Office Action Summary	Application No. 10/564,433	Applicant(s) CLASSEN ET AL.	
	Examiner FRANKIE L. STINSON	Art Unit 1792

2. Claims 10-18 are rejected under 35 U.S.C. 103(a) as being unpatentable over Dinh (U. S. Pat. No. 5,343,632) in view of France'322 (France 2 491 322) and Moratalla (U. S. Pat. No. 5,732,562).

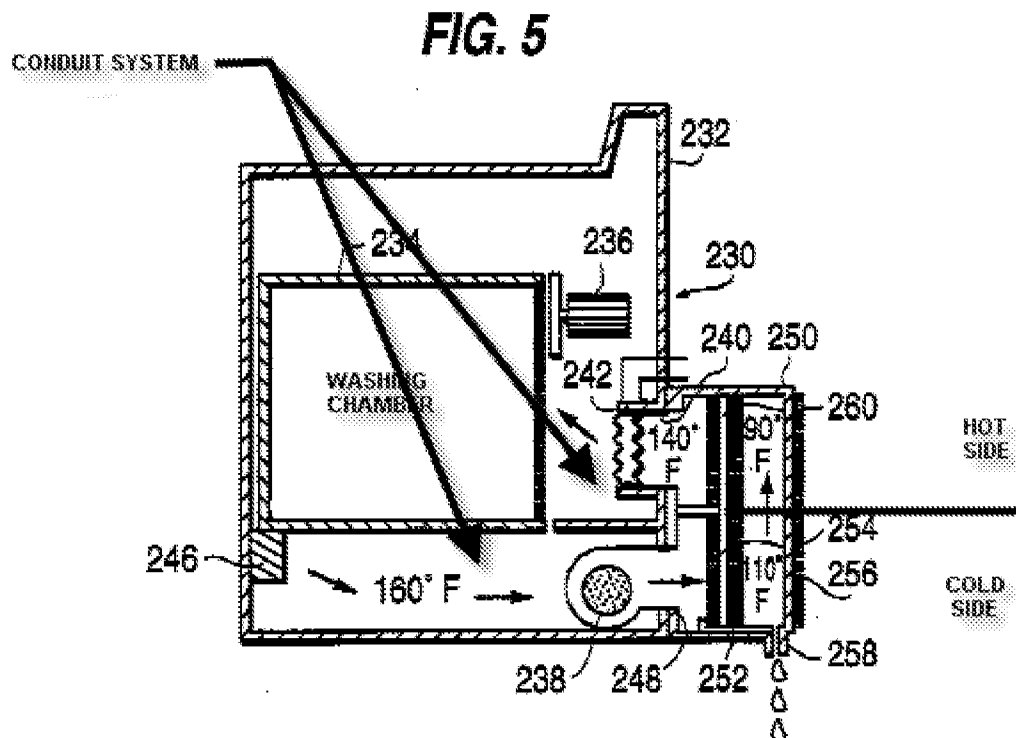
With Dinh disclosing the device for use with a dishwasher (col. 8, lines 9-10), it is understood, that instead of the drying chamber (234) as discloses in fig. 5, there would be a washing chamber as annotated in fig. 5 below, and therefore the following is provided.

Re claim 10, the patent to Dinh is cited disclosing a dishwasher comprising:

a washing chamber; and

a conduit system (see annotated fig. 5 below) connected to the washing chamber in an air-guiding manner such that air is guided from the washing chamber to the conduit system and air is guided from the conduit system to the washing chamber and the conduit system including a cold side portion (as at 256, see annotated fig. 5 below) and a hot side portion (as at 260, see annotated fig. 5 below), and including at least one heat pipe/tube (col. 5, lines 8-36) with heat pipe/tube extending into the cold side portion of the conduit system and into the hot side portion of the conduit system (see annotated fig. 5 below) and the conduit system being operable to guide air from the washing chamber through the cold side portion, whereupon the heat pipe/tube promotes a

cooling of air in the cold side portion of the conduit system (col. 7, lines 30-35) with a resultant condensing of moisture (as at 258) out of the cooled air, to thereafter guide cooled air from the cold side portion to the hot side portion,

whereupon the heat pipe/tube promotes heating of the air in the hot side portion of the conduit system (col. 7, line 67 thru col. 8, line 5), and to thereafter guide such heated air from the hot side portion to the washing chamber and the heat pipe/tube operating to conduct heat from the cold portion of the conduit system the hot portion of the conduit system with the heat pipe/tube receiving heat from air guided there past at the cold side portion of the conduit system and conducting such received heat to hot side portion that differs from the claim only in the recitation of the basket and the heat tube/pipe having a
